**SEISMIC/TORNADO ANALYSIS REVIEW  
FOR THE VITRIFICATION FACILITY  
AT WEST VALLEY**

**Nuclear Regulatory Commission  
Contract NRC-02-88-005**

**Center for Nuclear Waste Regulatory Analyses  
San Antonio, Texas**

**April 1993**

Figure 4-2. Reprocessing plant and VF elevation (N-S) (Gates, 1993)

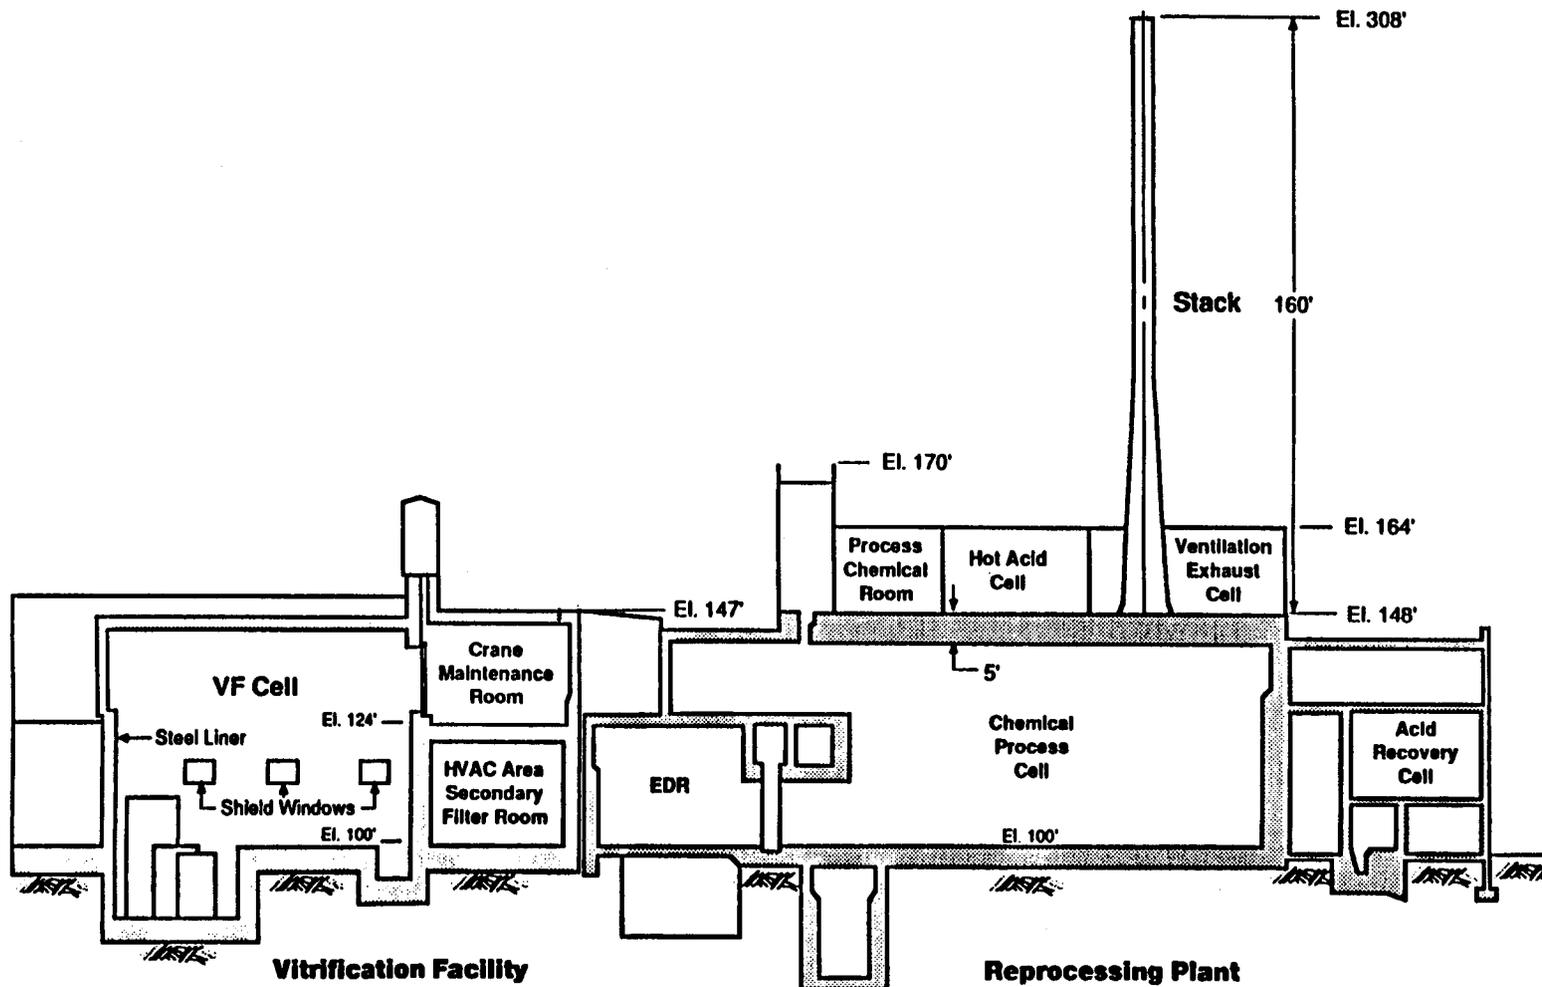
In addition to structural failure, the potential for contact between the VF cell and the Equipment Decontamination Room (EDR) (Figure 4-2) of the existing Nuclear Fuel Reprocessing Plant is determined to be remote. The maximum closure of the existing 3-in. gap is reported to be 0.8 in. Reduction of the soil damping to 10 percent could increase the deflection by a factor of 2 with a corresponding reduction in the margin of safety. The model utilized for this analysis is given in Figure 3-5. It basically consists of the VF stick model coupled to another stick model of the EDR.

In addition to structural failure, the potential for contact between the VF cell and the EDR of the existing Nuclear Fuel Reprocessing Plant (Figure 4-2) was calculated. The separation between the VF and the EDR during the seismic events is based on modeling the response of the building under the

influence of traveling seismic waves combined with the dynamic response of the buildings. This analysis showed a maximum of 0.8 in. closure for a total gap of 3 in., giving an acceptable margin of safety. Reduction of the soil damping to 10 percent could increase the deflection by a factor of 2, with a corresponding reduction in the margin of safety.

Figure 5-1. Horizontal design response spectra from RG 1.60 and ASCE No. 58 (RG 1.60)

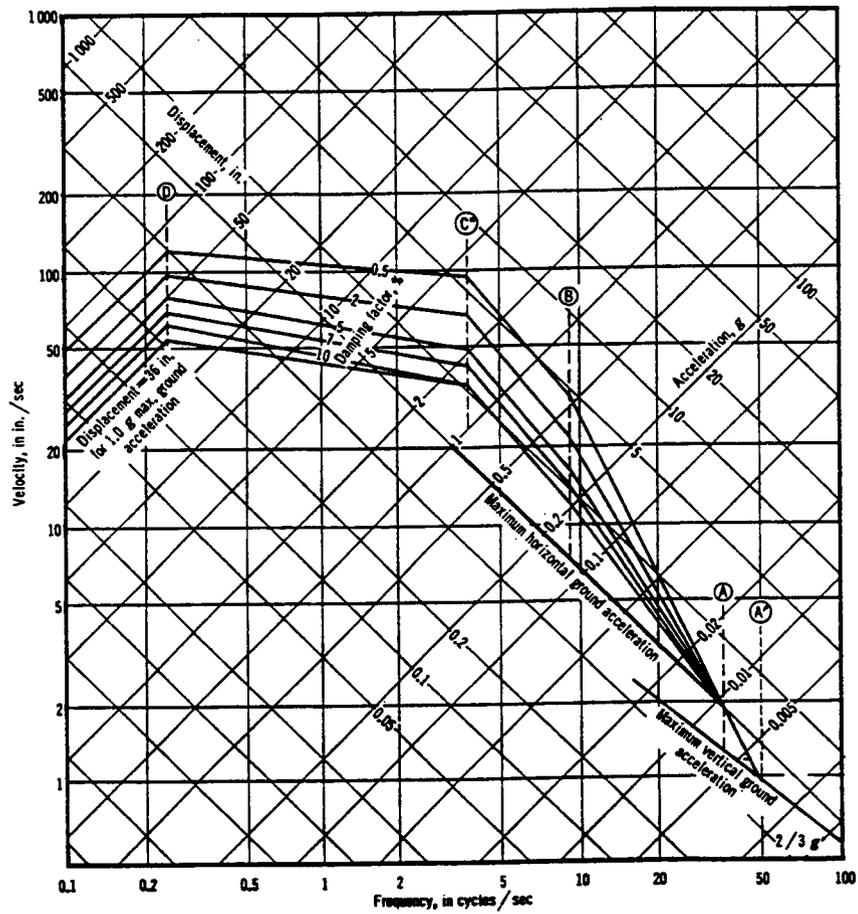
In general, the use of the RG 1.60 spectra is consistent with established procedures. The question that remains is, what is the peak acceleration to be used, based on the site and short operating period of the facility?

A large amount of analysis has been performed based on the 0.1 g levels and the RG 1.60 horizontal and vertical spectra (Figures 5-1 and 5-2). It is not necessary to re-analyze based on any updated level. For linear analysis, it is possible to apply a correction factor and develop new margins of safety for the seismic event. An additional factor that needs to be taken into account is the expected life of the plant, 5 years. This is less than the typical 30 to 40 years of a power plant and will influence the final determination of the overall margins of safety.
